# CITY OF ALBUQUERQUE

July 9, 2024

**RE: Event Center  
1611 Airtech Ct. SE  
Grading and Drainage Plans  
Engineer's Stamp Date:06/20/24  
Hydrology File: N15D017**

**RE: Event Center  
1611 Airtech CT. SE  
Comments dated May 28, 2024  
Hydrology File: N15D017**

SHEET TITLE  
**RETAINING WALL  
NO. 1  
PLAN & PROFILE**

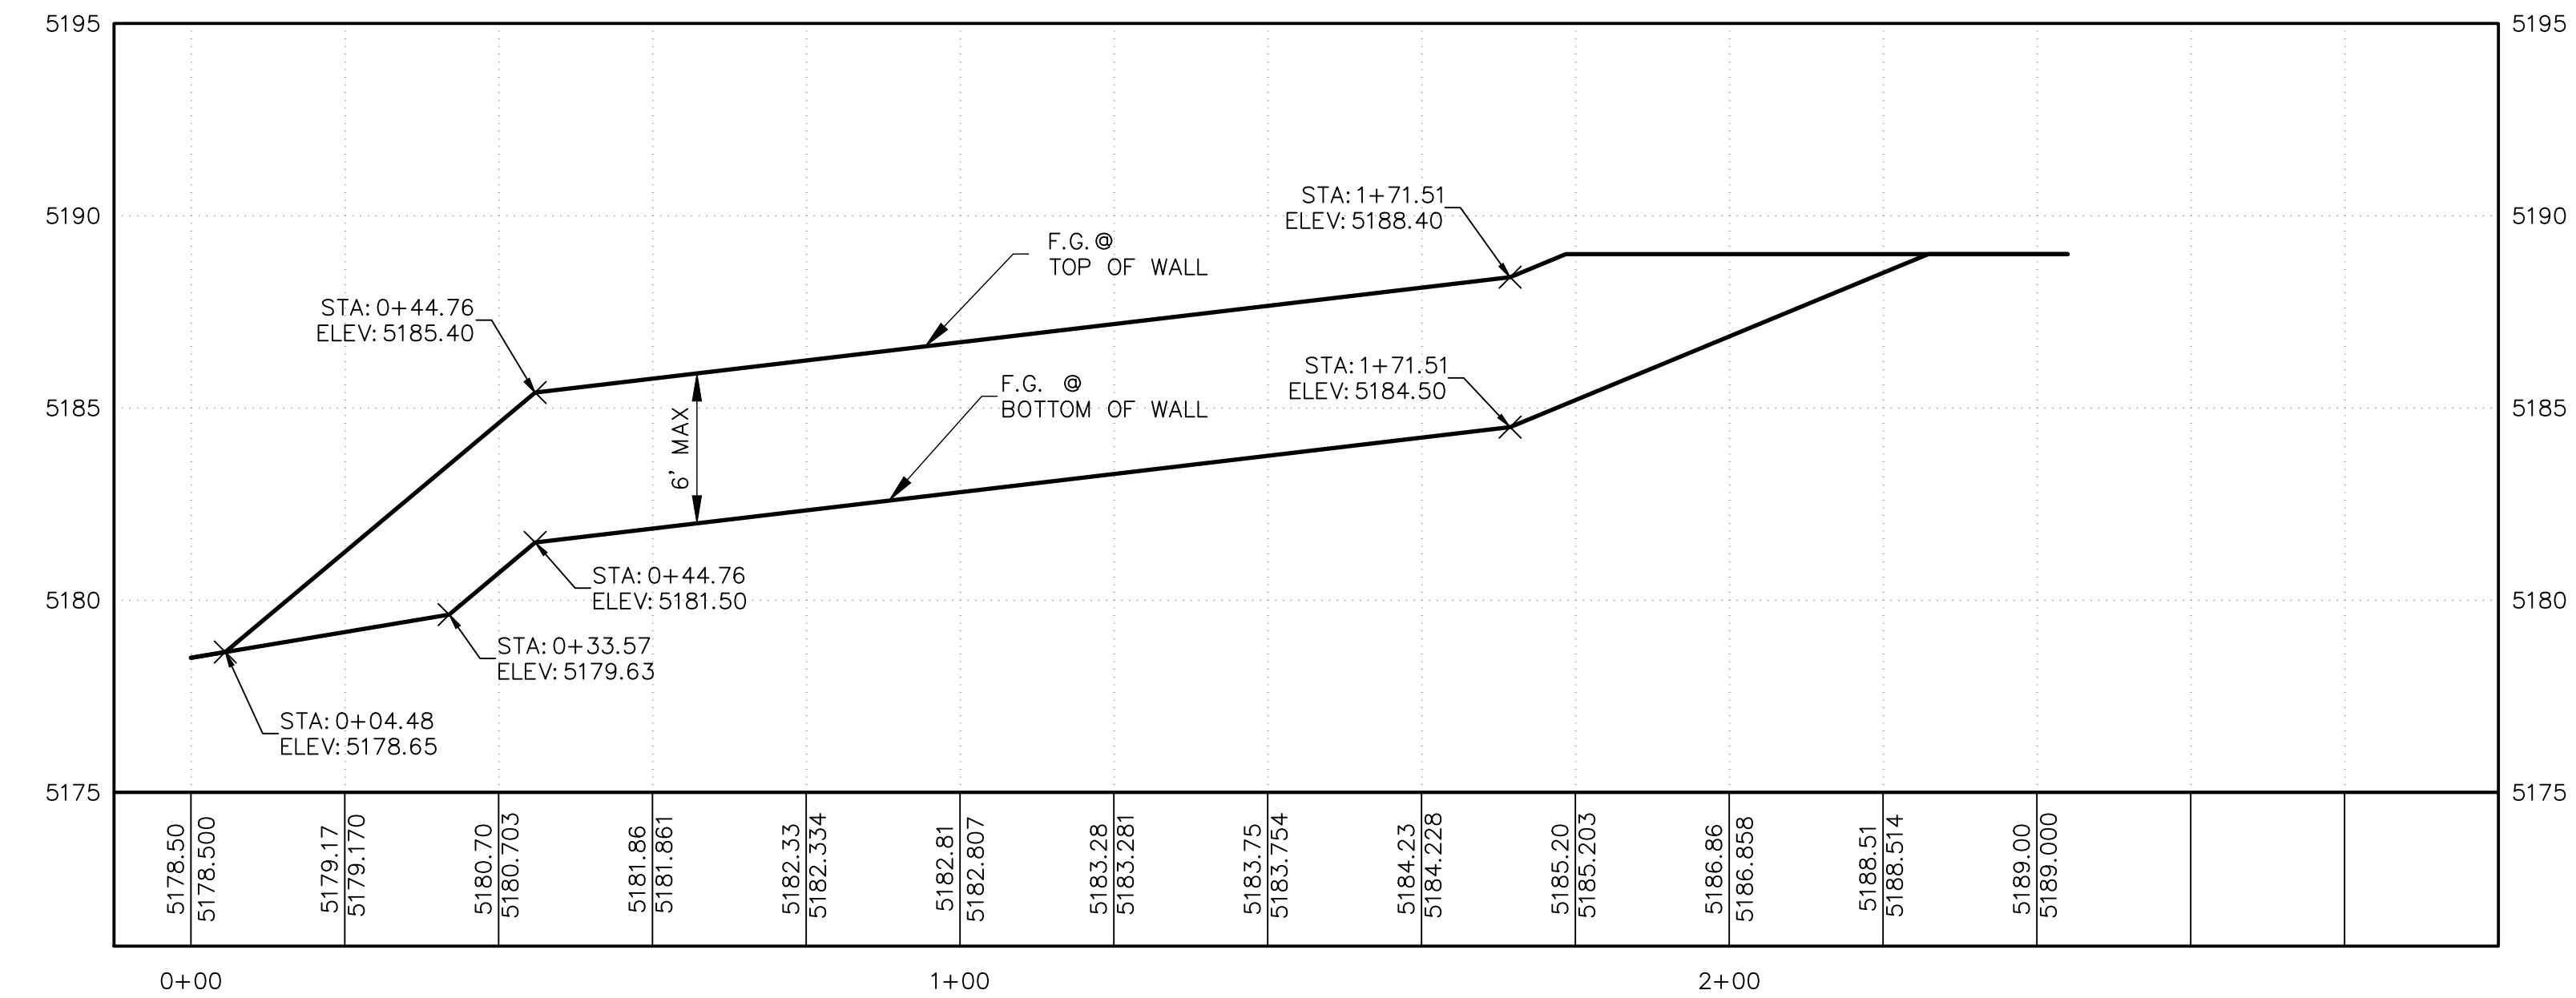
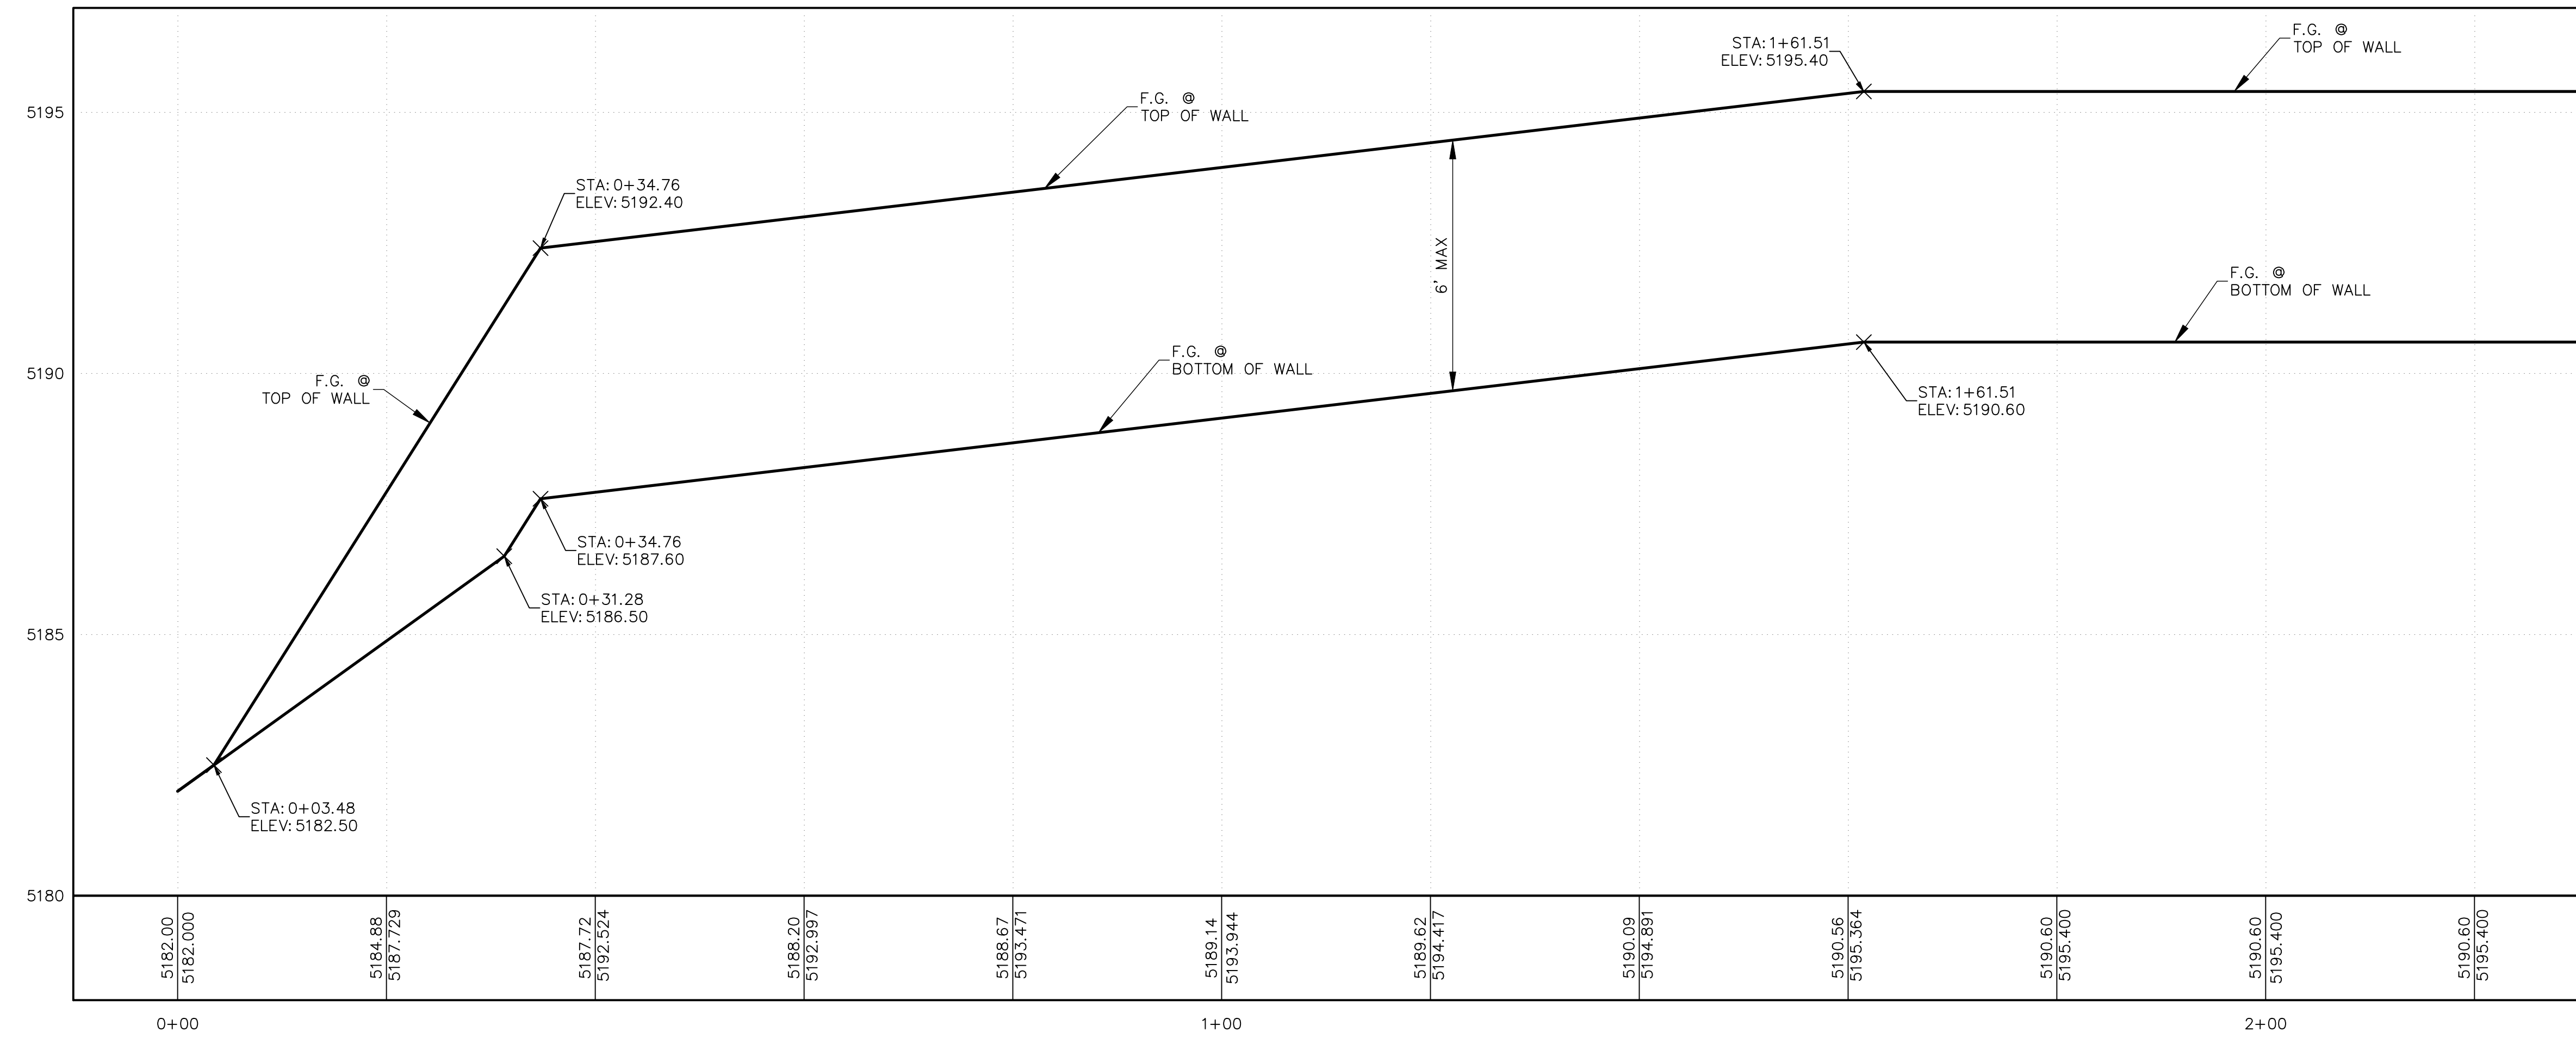
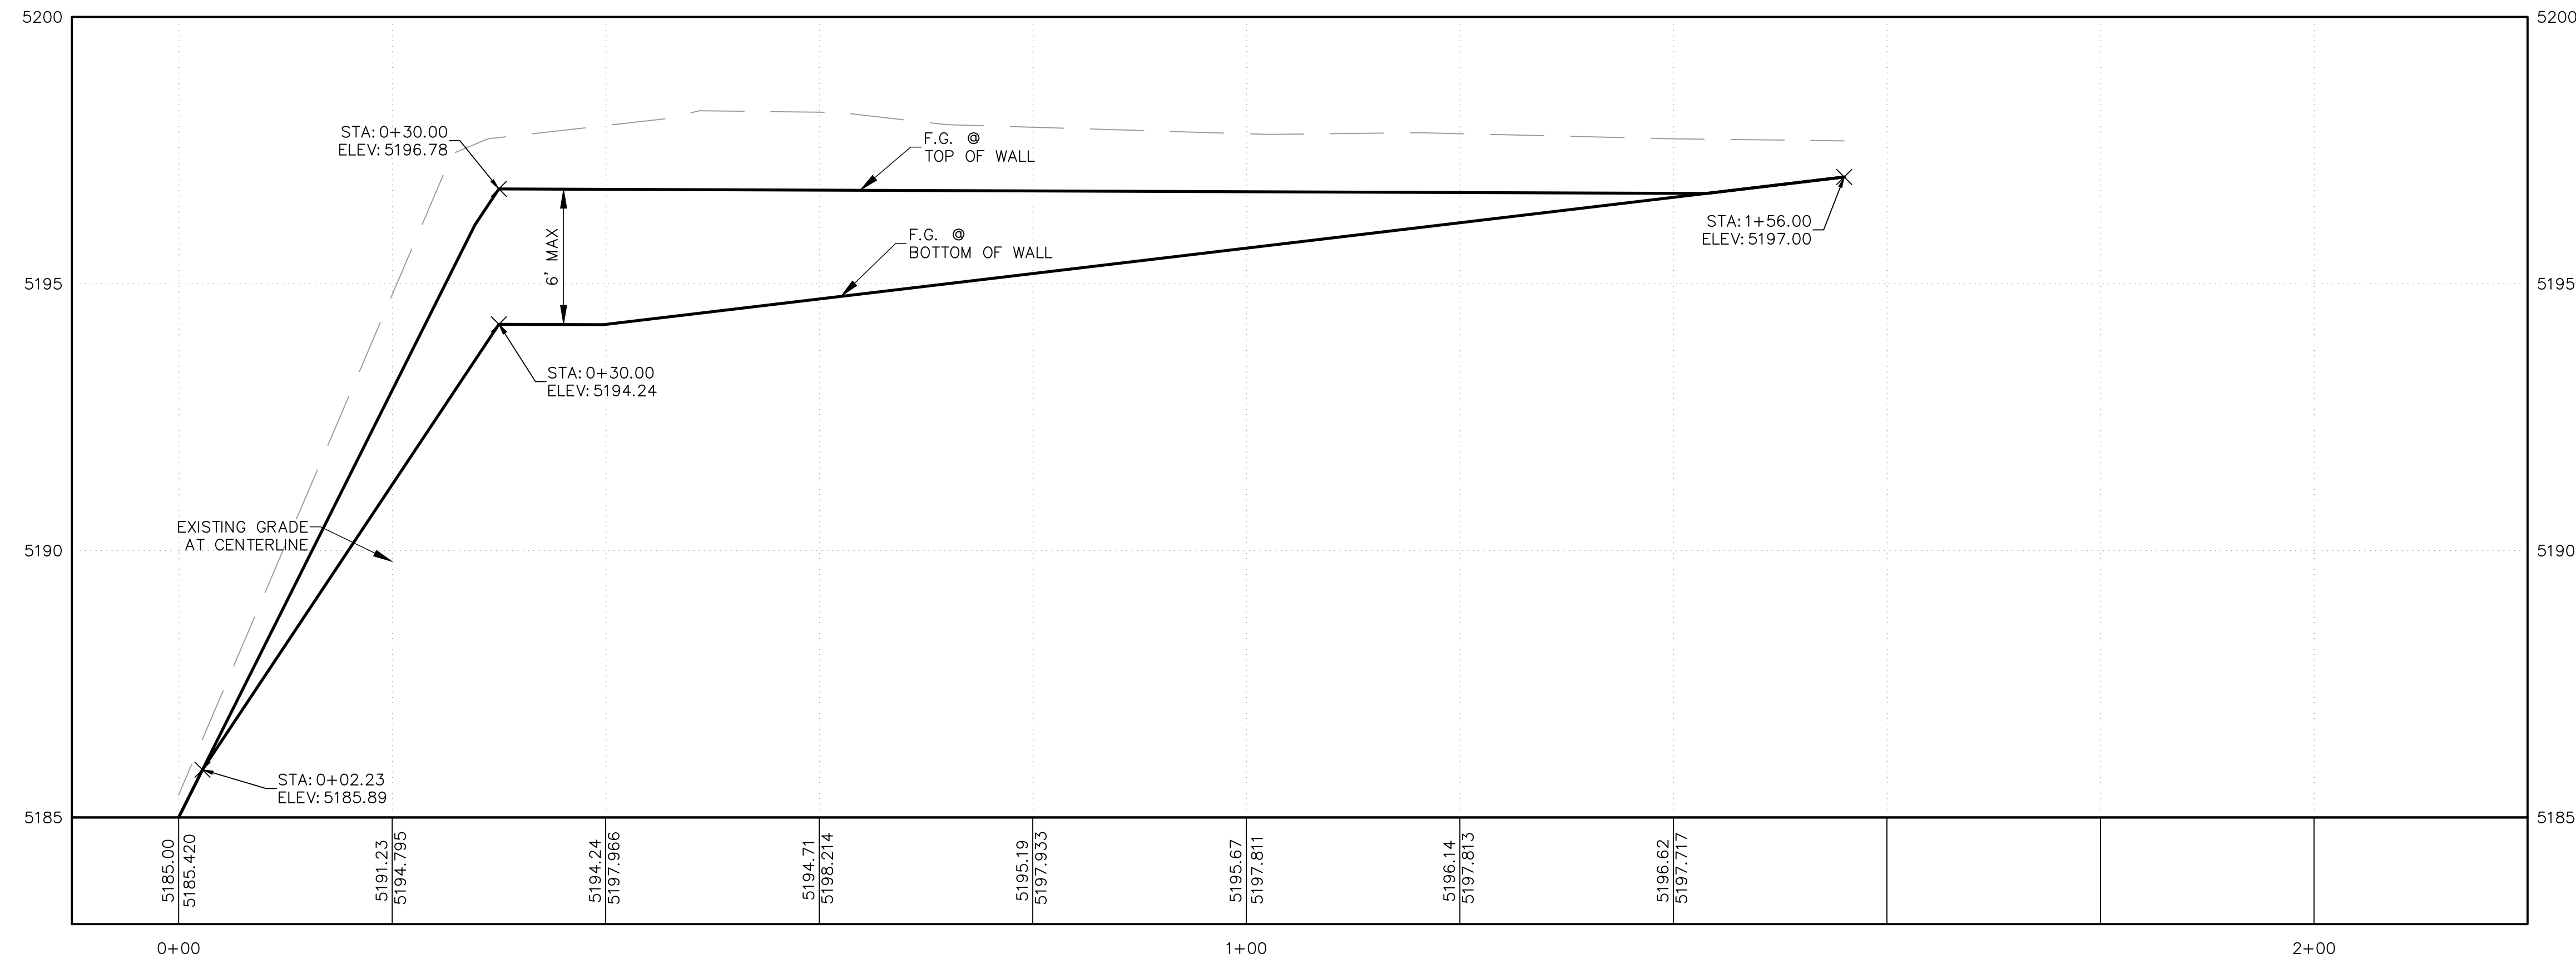
**Comment No. 8:** The retaining walls shown along the northern property line violates the IDO’s maximum wall height of 8 feet in total height. These walls have a total height of 19 feet.

- Response: Emailed the City Engineer on June 17<sup>th</sup>, 2024 seeking administrative approval of the retaining walls. To date, the City Engineer has not replied to the email.

The property is zoned NR-GM which allows retaining walls to have a maximum height of 10-feet with the current zoning. Retaining walls No. 1 through 3 were modified and if the wall height is greater than 10-feet, then the retaining walls were terraced with each separate wall not being greater than 6-feet. IDO Section 5-7(F)(2)(a) allows terracing the walls. Retaining Walls No. 1 through 3 now meet IDO Section 5-7(F)(2)(a) requirements.

DESIGNED BY: R/JF  
DRAWN BY: JB  
CHECKED BY: R/JF  
DATE: JUNE 2024  
SHEET TITLE  
**DRAINAGE PLAN**  
SHEET NO:  
**D-1**

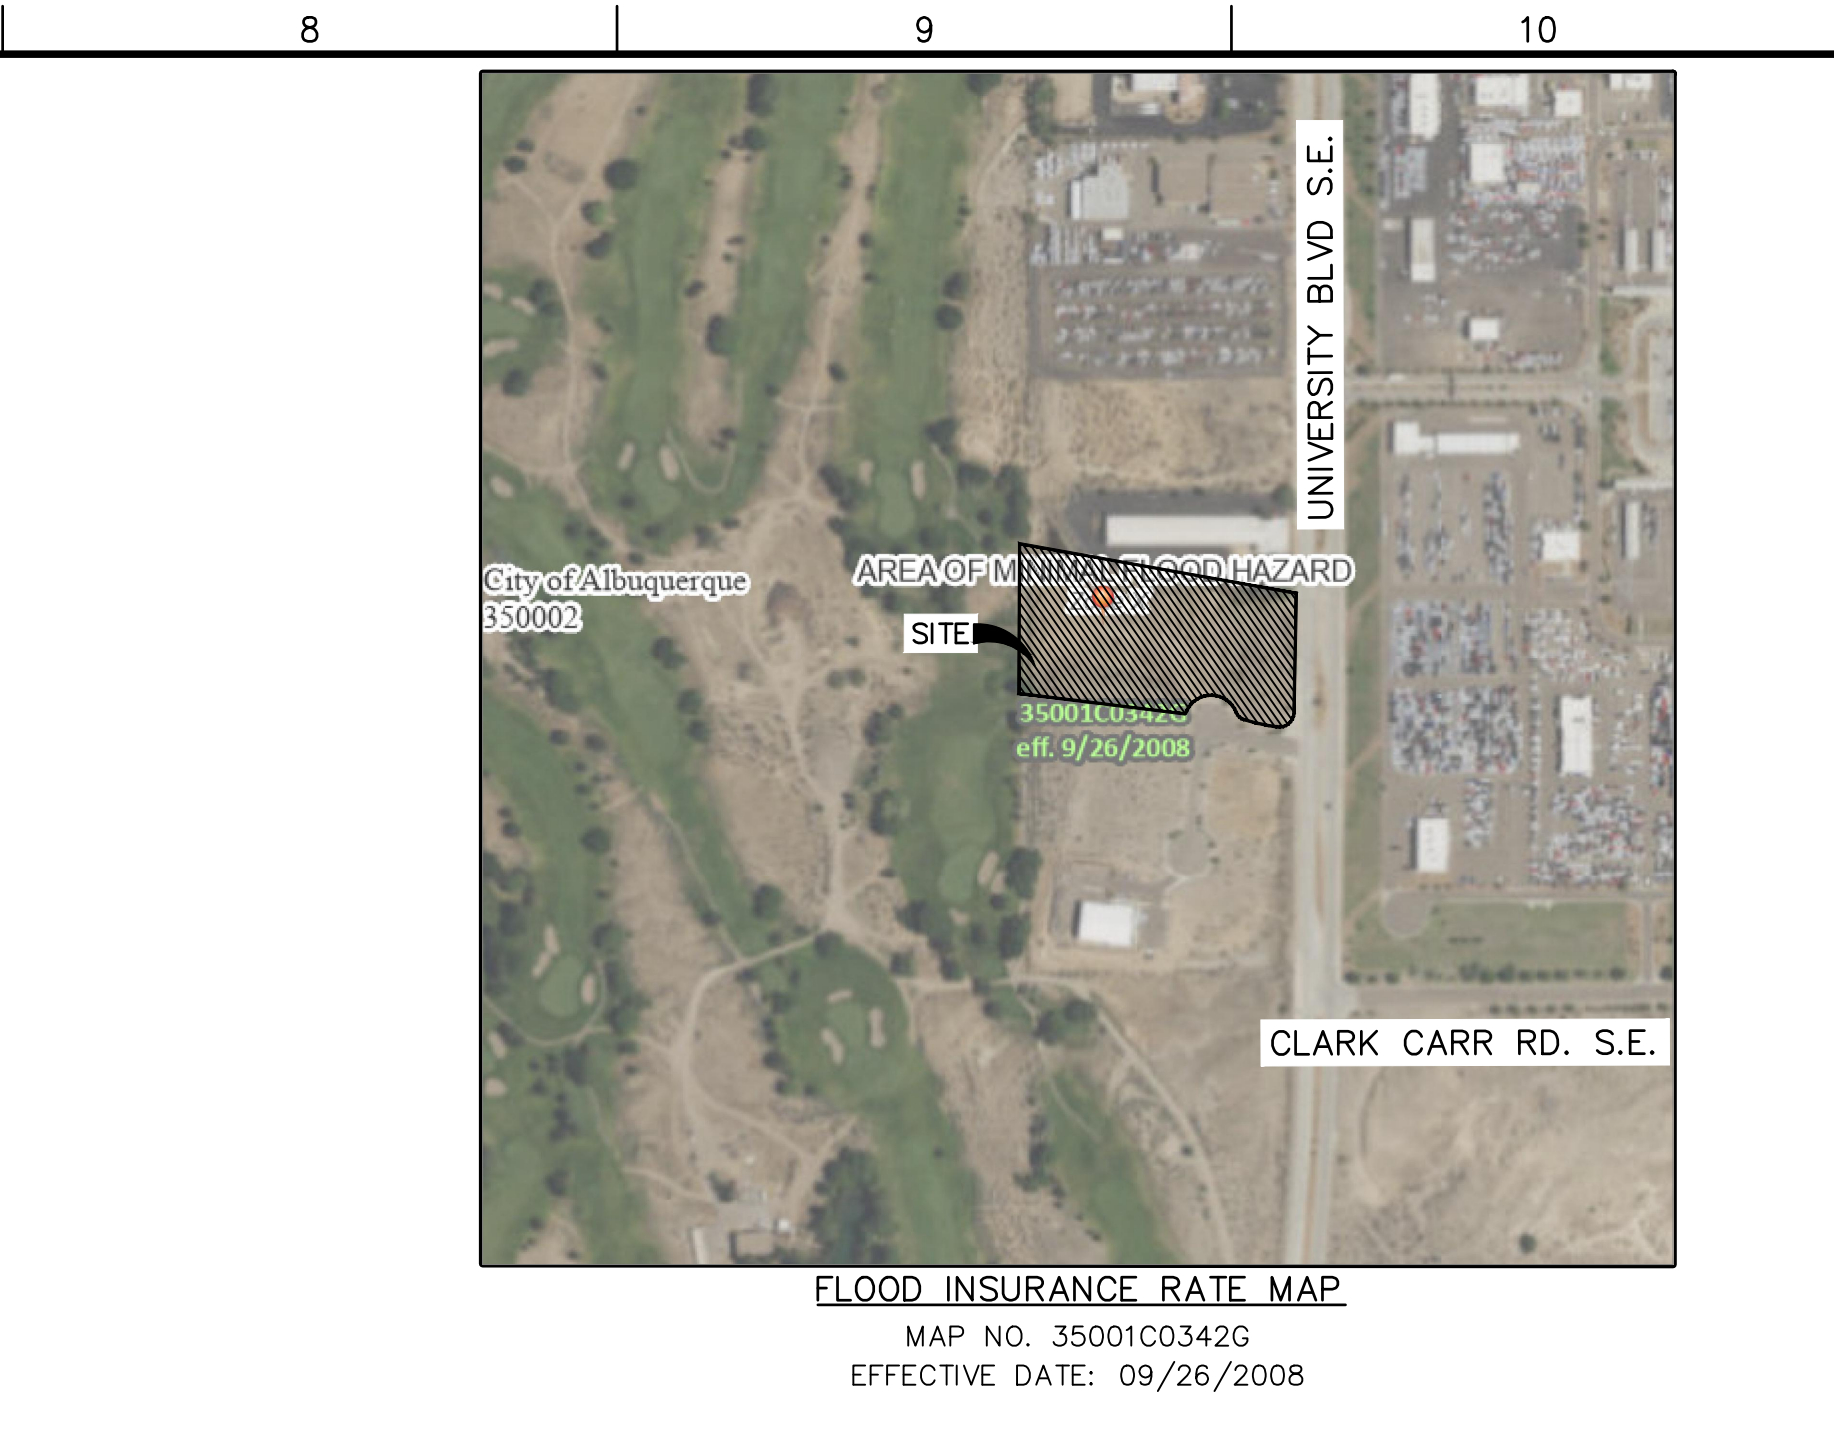
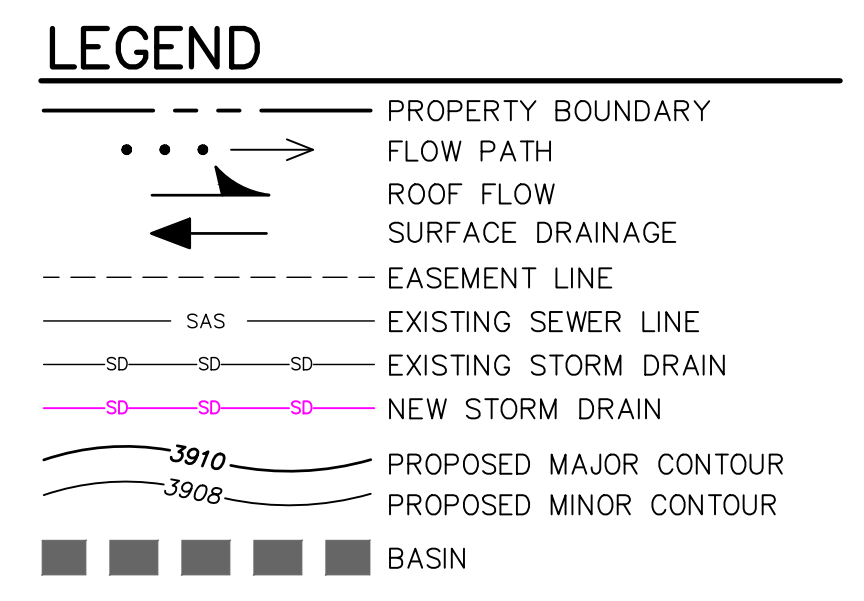
**Comment No. 10:** On the Drainage Plan under the Existing Conditions, please state that this tract is within the Master Drainage Plan for Lots 6B-2 and 8B, Airport Technical Center with an allowable discharge rate of 16.4 cfs.

- Response: Language added.
